FIRE SAFETY INSPECTION REPORT

**STARLIGHT SWEATERS LTD.
VOGRA NATIONAL UNIVERSITY, GAZIPUR, SADAR**

ACCORD
on Fire and Building Safety in Bangladesh

March 22, 2014

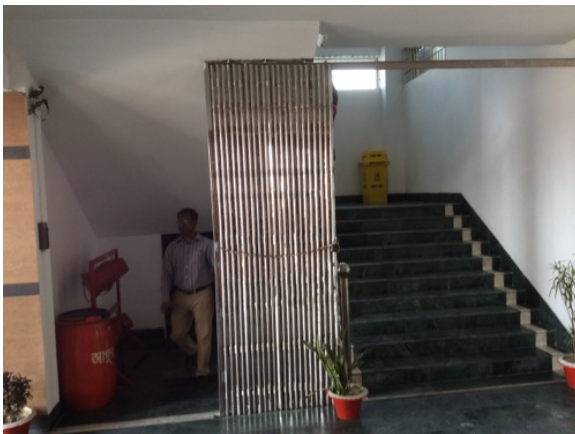
F-8	Fire Rated Construction	Diesel storage area is not separated by fire-rated construction.	Separate the diesel storage by a minimum 2-hr fire-rated construction. Seal and/or protected all openings to maintain the required fire separations.	Within 3 months
-----	-------------------------	--	--	-----------------

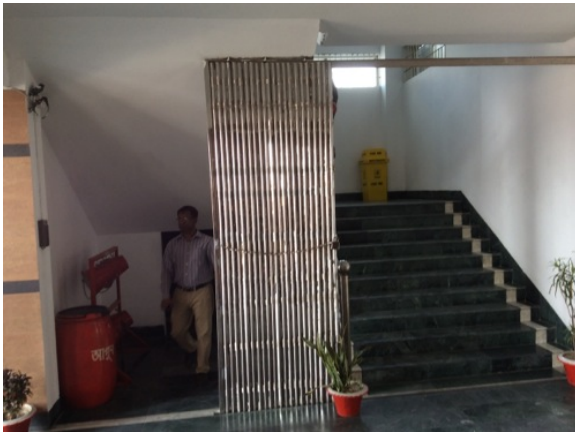
F-11	Egress	Sliding gates / doors are provided throughout the stairwells, building exits, along egress routes, exit discharge.	Replace all gates / sliding doors along the means of egress with side-hinged, swinging egress doors.	Within 1 month
			If locks are required for security reasons, utilize special door locking features complying with NFPA 101.

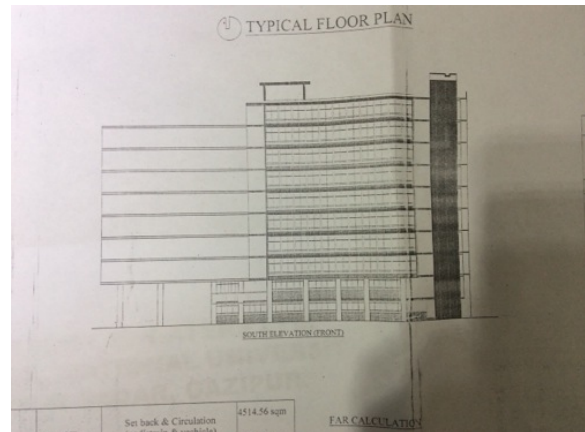
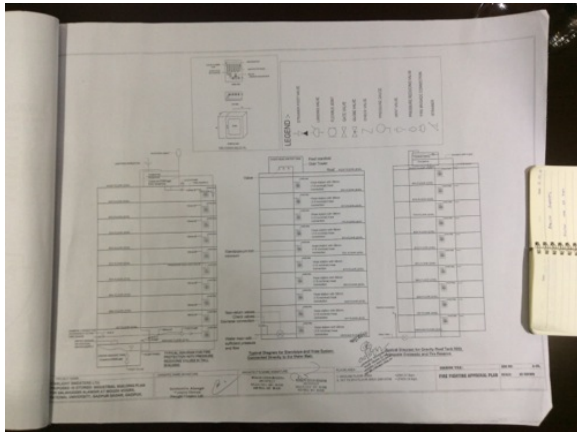
F-17	Fire Protection	The high-rise building has an occupied floor greater than 23m (75 ft) and is not provided with automatic sprinkler protection. The large occupant loads, heavy fuel loading, and anticipated extended egress times warrant sprinkler protection.	Provide automatic sprinkler protection throughout the building in accordance with NFPA 13.	Design within 6 months, install within 12 months
------	-----------------	--	--	--
